PLANNING AND ZONING

COMMISSION AGENDA

Wednesday, September 11, 2024

2. **PZC 2024-01 Yorkville Renewables, LLC**, contract lessee, and Daniel A. and Charene S. Nagel, property owners, petitioners, have filed applications with the United City of Yorkville, Kendall County, Illinois, requesting rezoning classification, special use authorization, and a bulk regulation variance approval. The real property is located on the southwest corner of Galena Road and Illinois Route 47. The petitioners are requesting rezoning approval from R-2 Single-Family Traditional Residence District to A-1 Agricultural District. The petitioners are also requesting special use permit approval in pursuant to Section 10-8-5 of the Unified Development Ordinance for a solar farm. Lastly, the petitioners are requesting a bulk regulation variance to Section 10-4-13.B of the Unified Development Ordinance requesting a reduction in the north, west, and south property lines setback from 50 feet to 8 feet.

Fencing

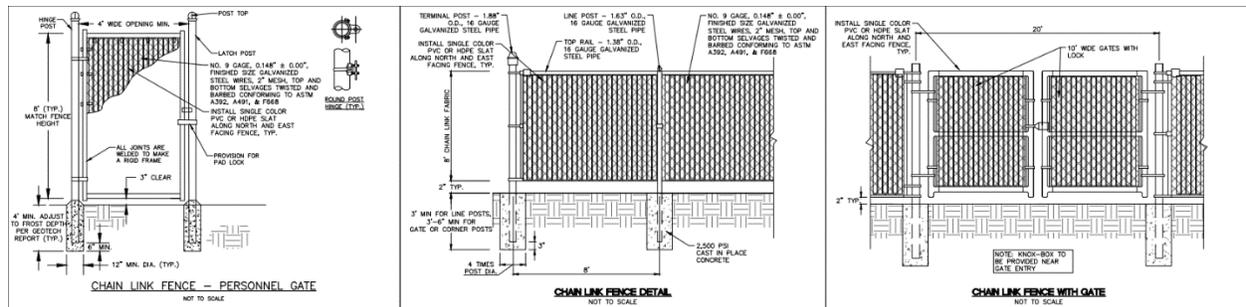
The petitioner has proposed an eight (8) foot tall, galvanized chain link fence with slats to surround the ~4,600 linear foot perimeter of the solar farm with a 20-foot-wide vehicle access gate, as illustrated below. As stated in Section 10-4-13B.9 of the Unified Development Ordinance, Fence Regulations for Solar Farms, states that systems, equipment, and structures shall be fully enclosed and secured by a fence or wall with a height of eight (8) feet. Petitioner’s exhibit (Sheet C-600 C Standard Details) indicates the Knox-Box location on the fence that has been added to the Gate Detail for the City’s Building Department and Bristol Kendall Fire District (BKFD) in the event of an emergency.

- Staff recommends an 8' tall, galvanized chain link fence with slats. **Nexamp Response: The fence detail on sheet C-300 has been revised to reflect this recommendation.**
- A Knox box and keys shall be provided to the City's building department and Bristol Kendall Fire District (BKFD). **Nexamp Response: A note indicating the Knox-Box location on the fence has been added to the Gate Detail on sheet C-600**

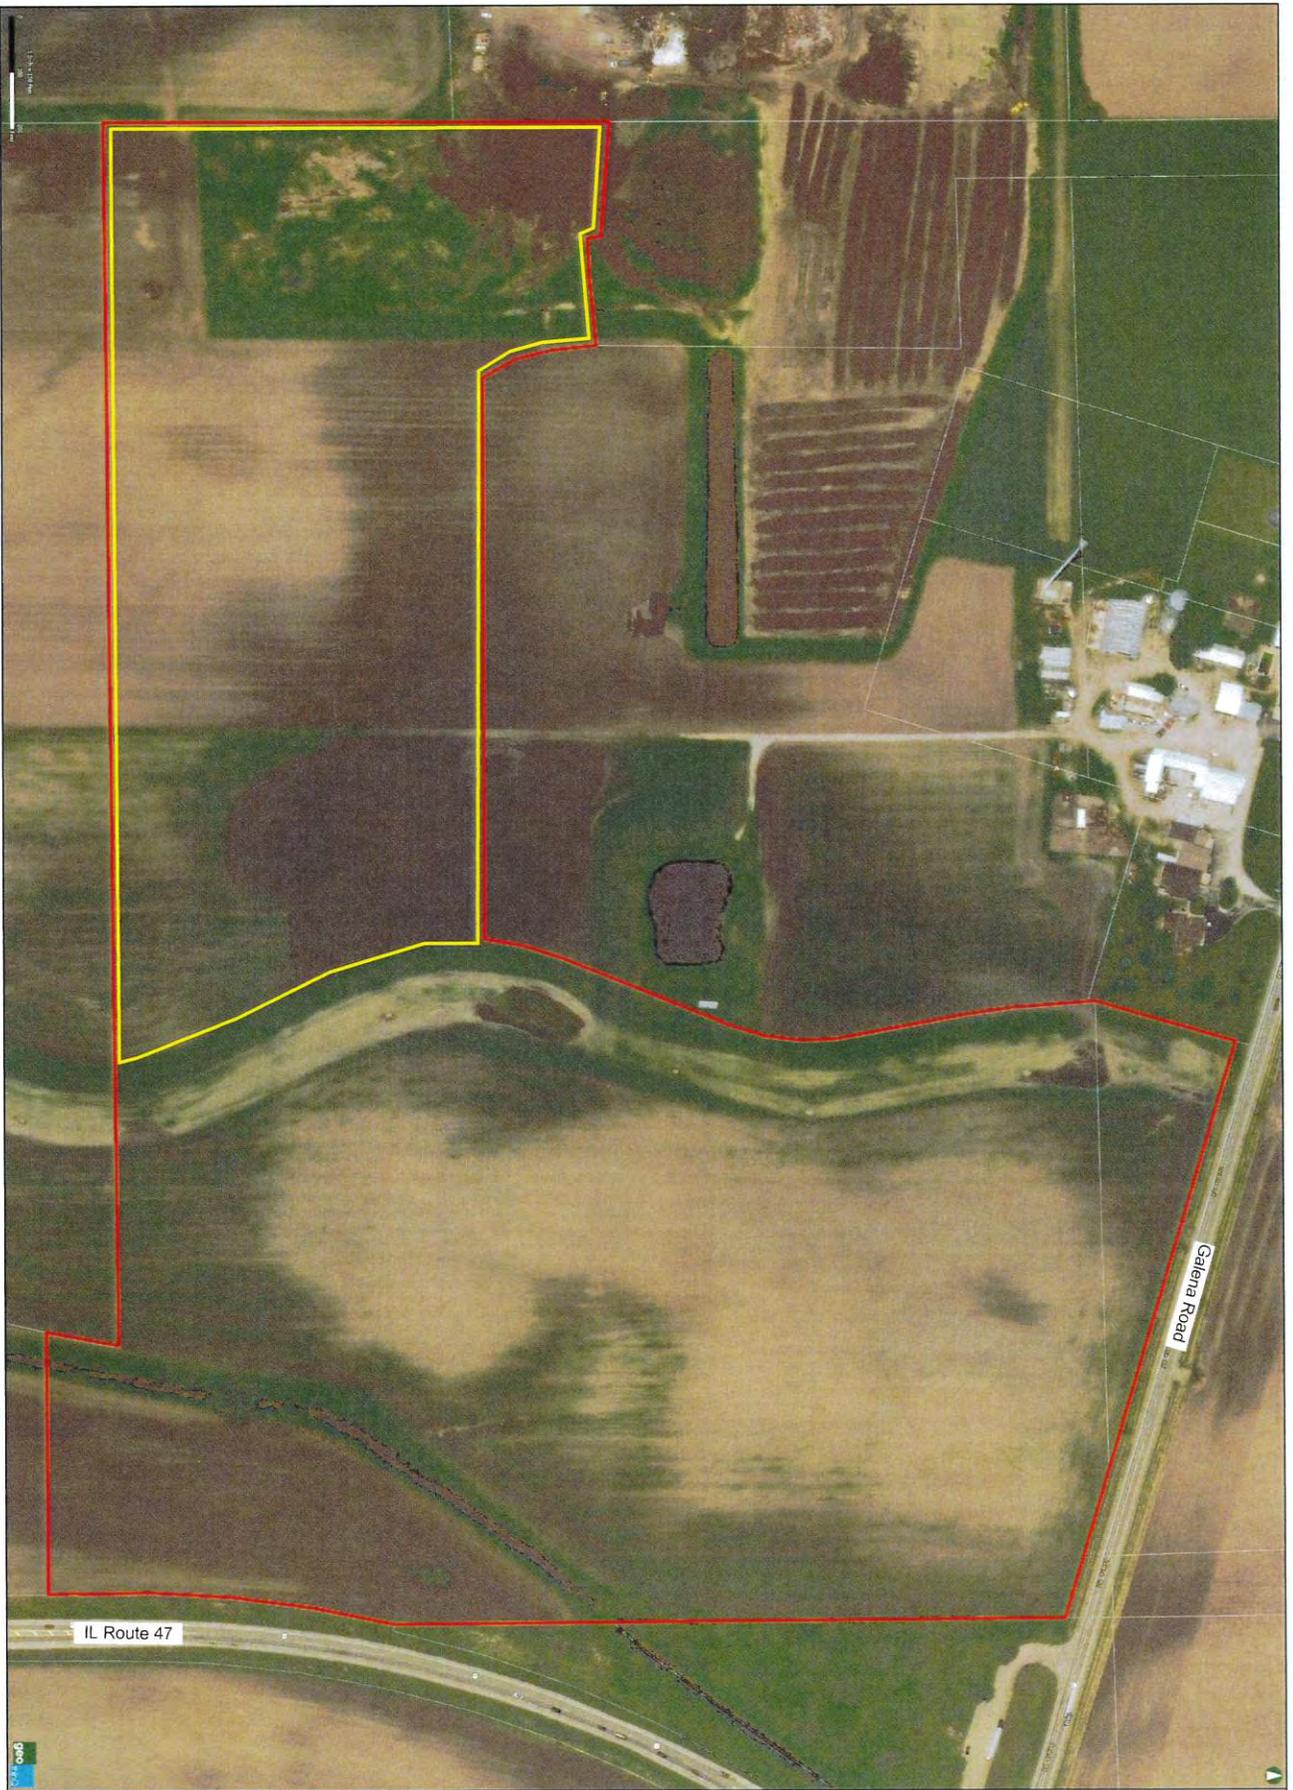
- The petitioner's exhibit (Sheet C-06 A Standard Details) appears to indicate a maximum solar array height as approx. 20 feet at maximum tilt. **Nexamp Response: Confirmed.**
- The petitioner's exhibit (Sheet C-06 A Standard Details) appears to indicate a minimum solar array clearance as 2 feet. **Nexamp Response: Confirmed.**
- A variance will be required for the minimum clearance requirements. **Nexamp Response: Noted.**

DETAILED SITE ENTRANCE GRADING - GALENA ROAD SCALE 1" = 30'

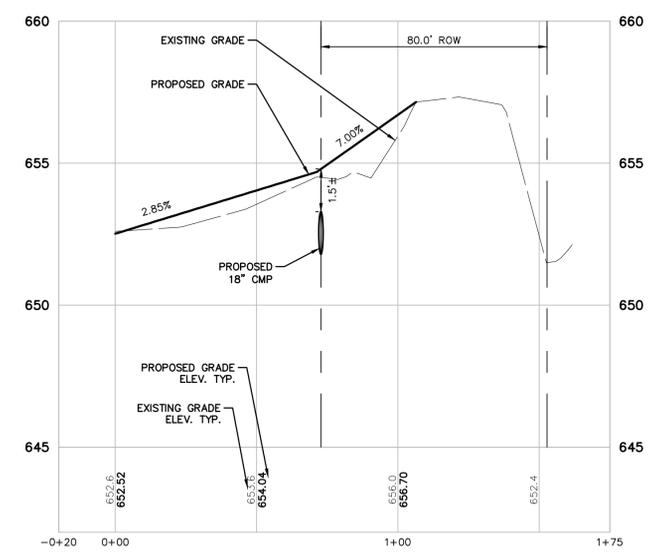
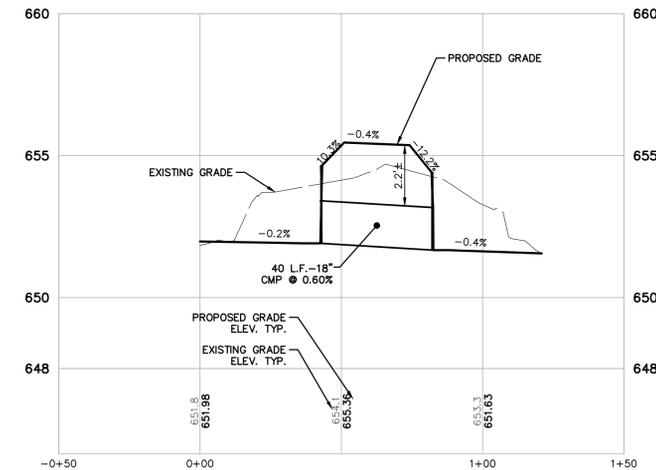
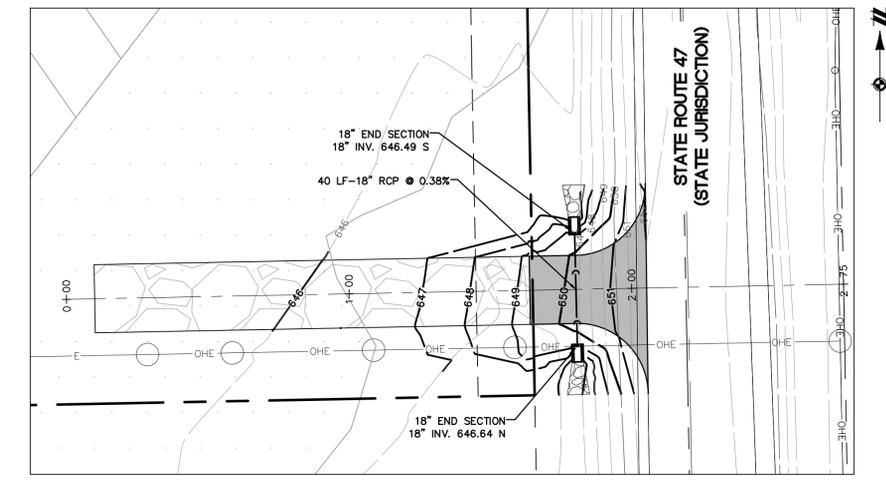
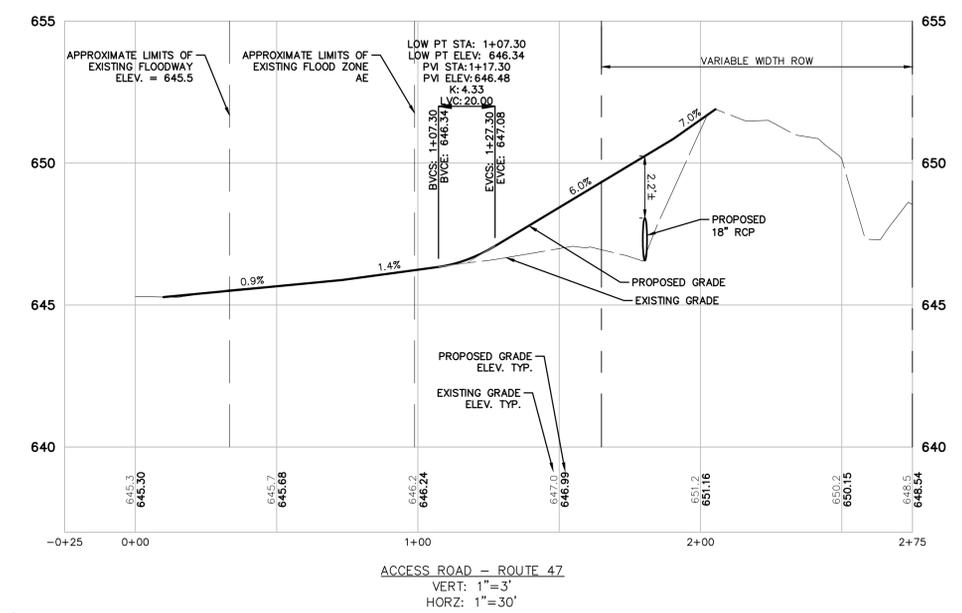
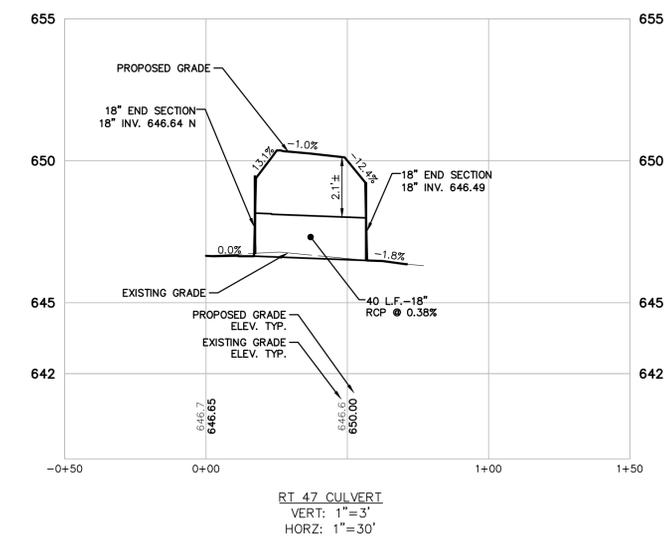
We have gone through and revised the plans to show the removal of the 8" PVC and replacement with an 18" CMP culvert as recommended (See sheet C-05). I will provide a link to the revised plans below (dated 2022-10-27). Please let us know if this new culvert layout is satisfactory, and if so, we will move forward using this culvert layout for the project.
